**ADVISORY REPORT**  
**FINDINGS, CONCLUSIONS, AND RECOMMENDATIONS**

**To:** Kirkland Hearing Examiner

**From:**  Désirée Goble, AICP, Project Planner  
 Eric R. Shields, AICP, Planning Director

**File:** SPL07-00008, SHR07-00001, ZON07-00004 MCLEOD TWO LOT SHORT PLAT, FRONT YARD, NORTH PROPERTY LINE AND VIEW CORRIDOR VARIANCE

**STREET LEVEL PLAN**

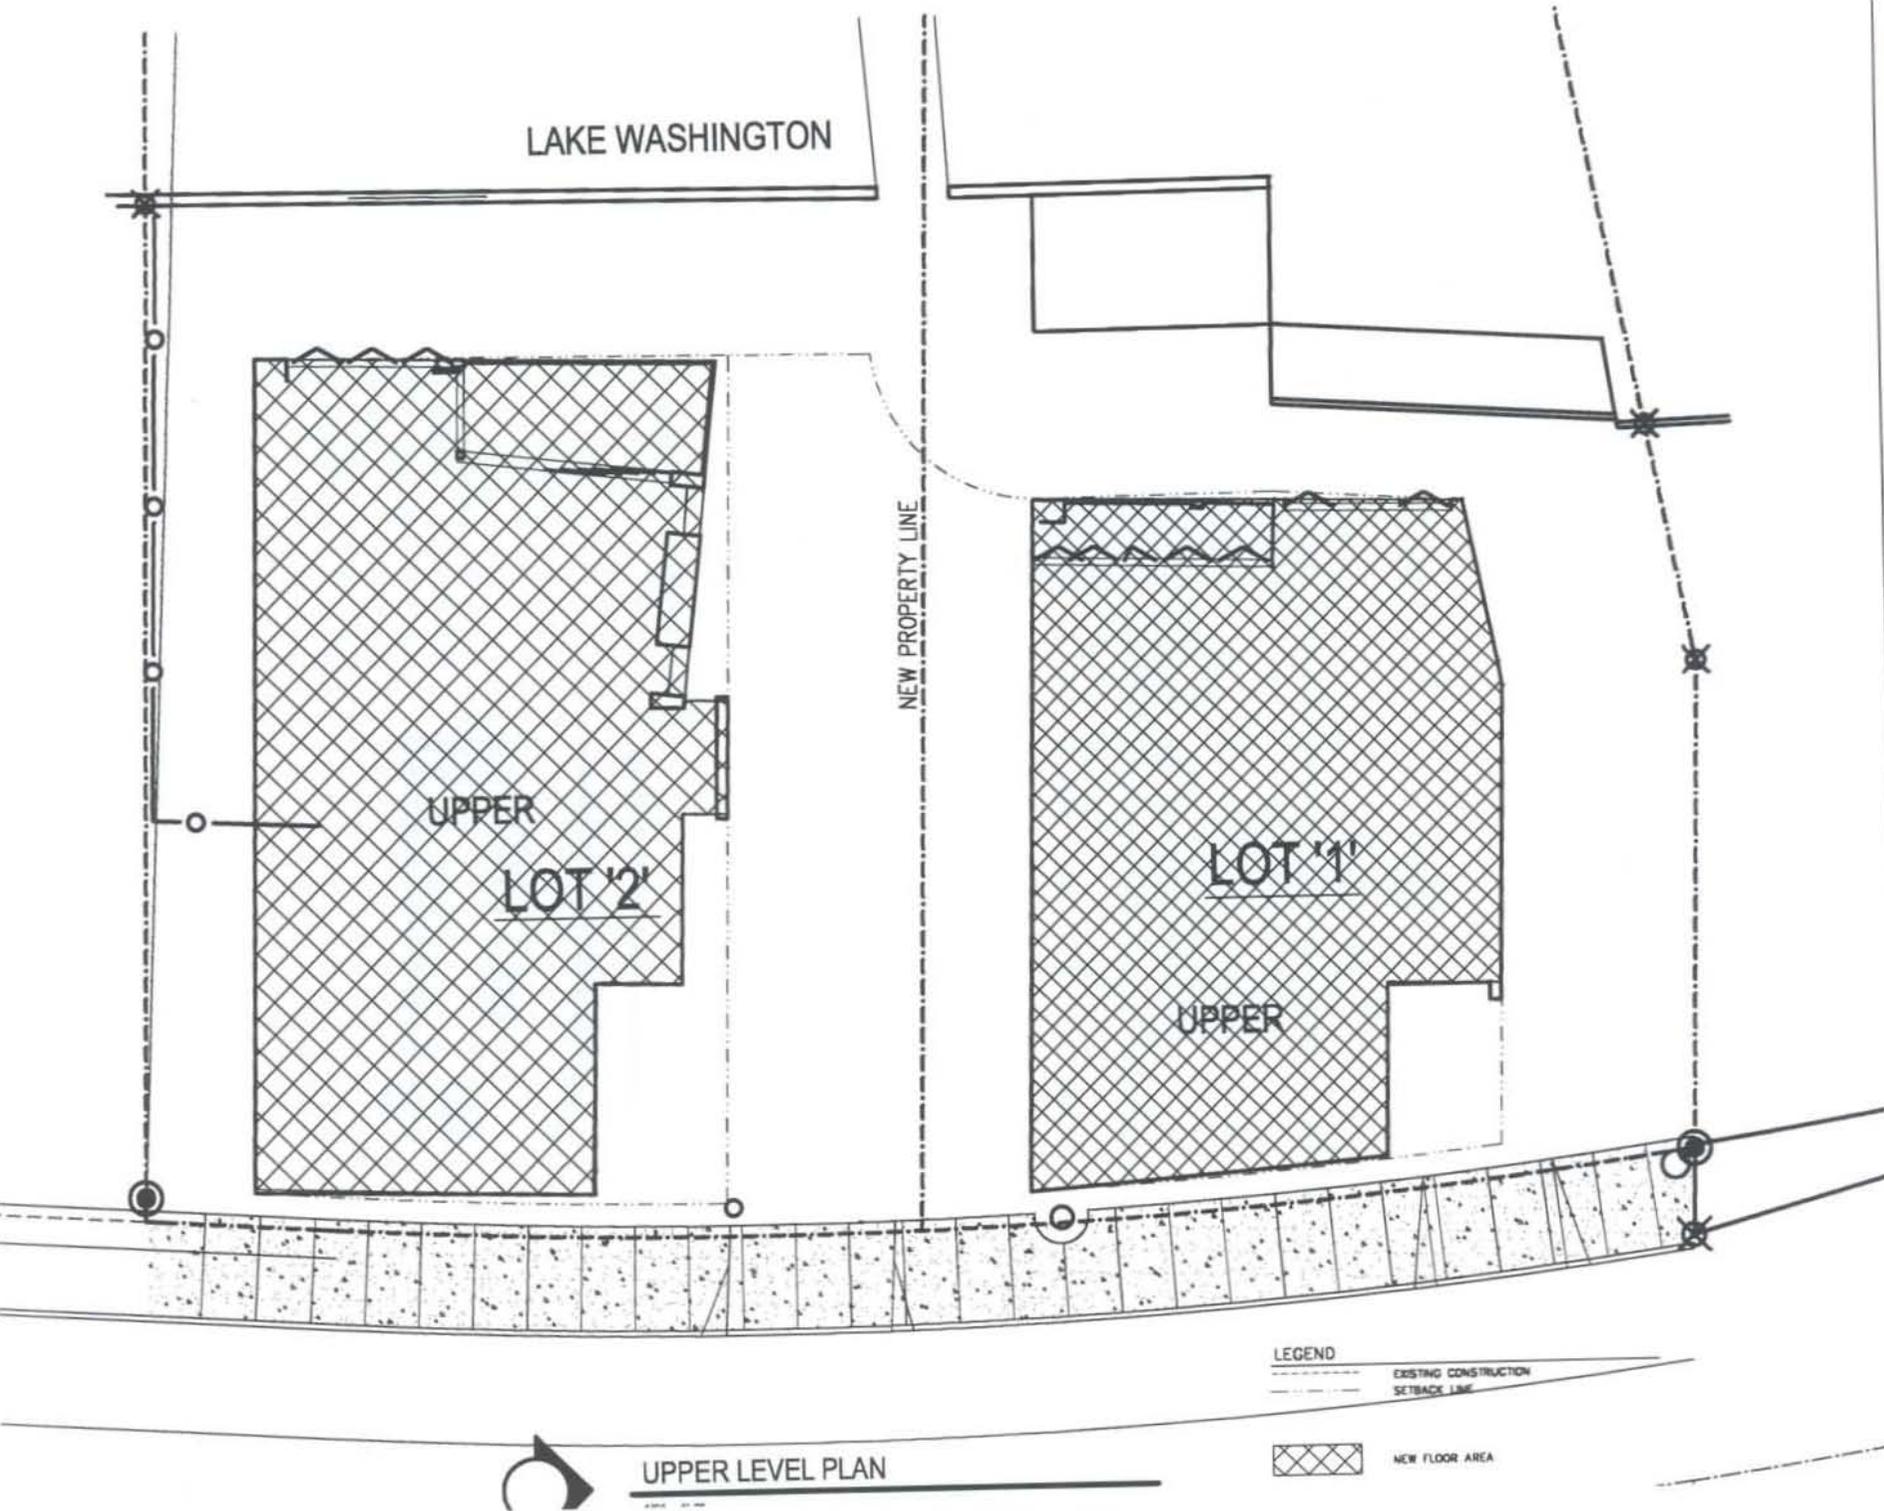
The applicant is proposing to place the garages on both lots three feet behind the front property line with garage doors set perpendicular to the right-of-way. The garage on lot 1 is 28.2 feet deep by 21 feet wide. The second story above the garage would be set back six feet from the front property line. A deck is proposed between the second story and the eastern facade of the garage and would be surrounded by a solid sight obscuring railing. The deck cantilevers north of the garage facade approximately five feet. The garage on lot 2 is 25 feet deep by 23.5 feet wide. The second story above the garage is not set back further from the front property line and actually cantilevers northward approximately six feet from the garage. A deck is proposed above the northeast corner of the garage.

Conclusion: The proposed front setback reductions for the garages with cantilevered living space above will be materially detrimental to the city because it will place two story facades with little architectural relief in close proximity to the public right-of-way. The proposed two story façades with cantilevers that extend further into the front setback yard will be imposing for pedestrians. A single story façade along the street, with open but useable space above, can provide architectural interest and would reduce the mass of the buildings. The applicant should increase garage setbacks to five feet to provide a sufficient depth for plantings of varying heights and widths between garage and sidewalk. The second story should be set back further to be consistent with intent of General Regulation 3. Structures over the garage should be set back at least 15 feet. However, decks may be located within this setback providing that open or see through railings are used. The remaining portion of the house should meet the one to one setback requirement of General Regulation 3.

- d. Increase the garage setbacks from the front property line to five feet (see Conclusion II.F.4.c).
  - e. The portions of the second story over the garage are set back at least 15 feet from the front property line. Decks can be located within this setback provided that open or see-through railings are used (see Conclusion II.F.4.c).

UPPER LEVEL PLAN

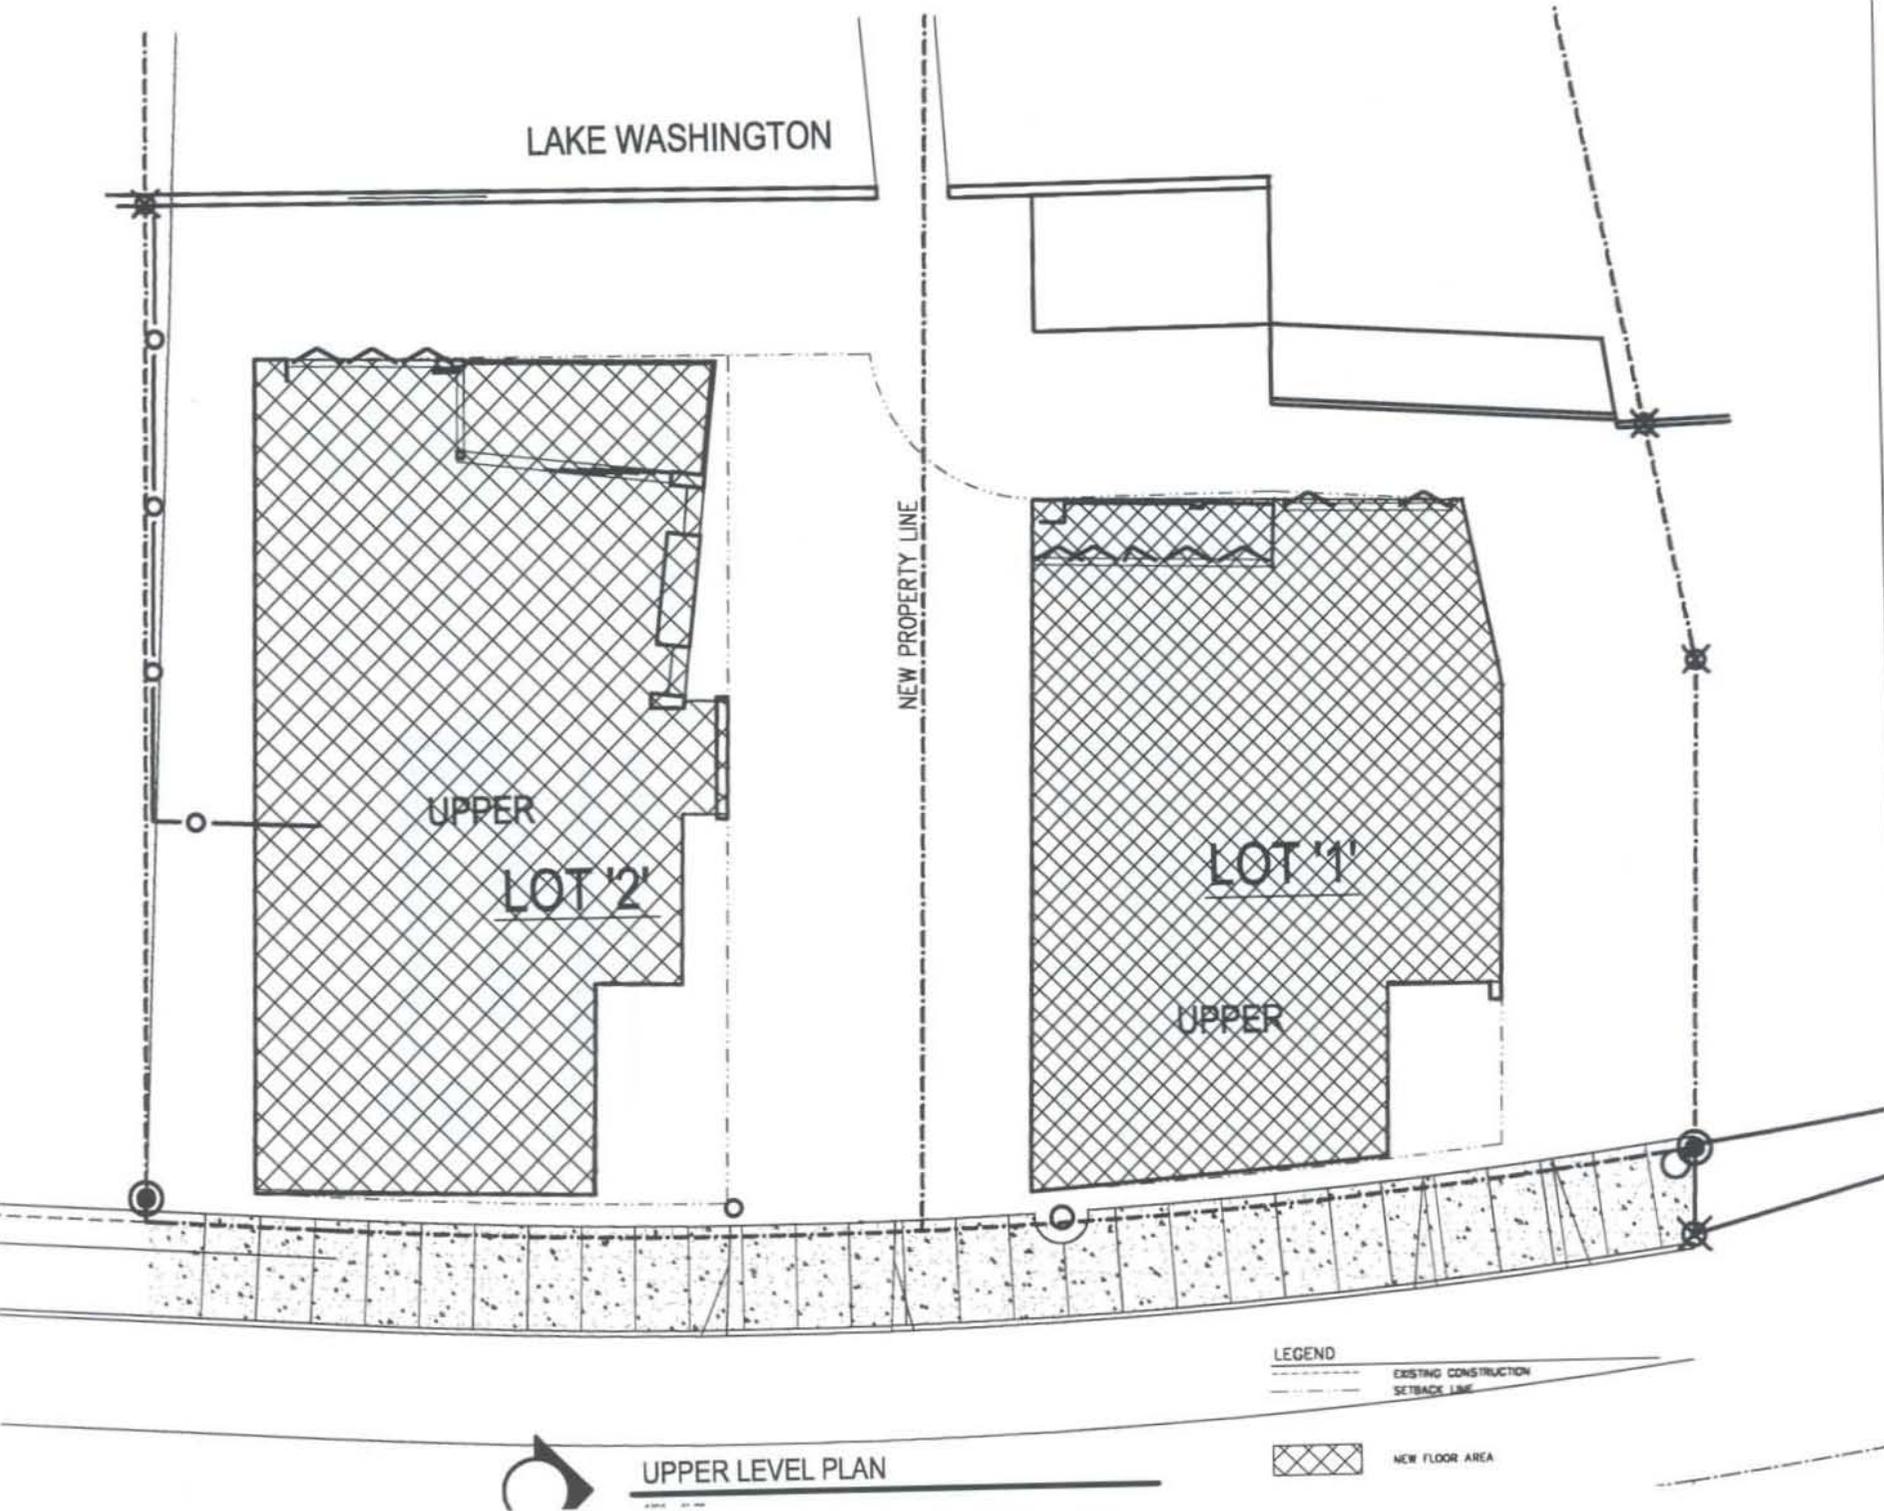
The applicant is proposing the following setbacks from the north property line: lot 1 would set the garage back 32 feet, the second story cantilever 29.5 feet, and the remainder of the house 17.6 feet. Lot 2 would set the garage back 35 feet, second story cantilever over the garage 32.5 feet, and the remainder of the house 17.7 feet.

- (2) Conclusion: With the view corridors recommended by staff, the development will maintain a sense of openness between buildings and allow light to reach the adjoining property to the north. A reduction in the north property line setback to 32 feet on lot 1 for the garage and 21.2 feet for the remaining portions of both houses west of the garage will not be materially detrimental.

- c. The remaining portions of the house above the garages on lots 1 and 2 shall meet the north property line setback requirement (see Conclusion II.F.4.b).
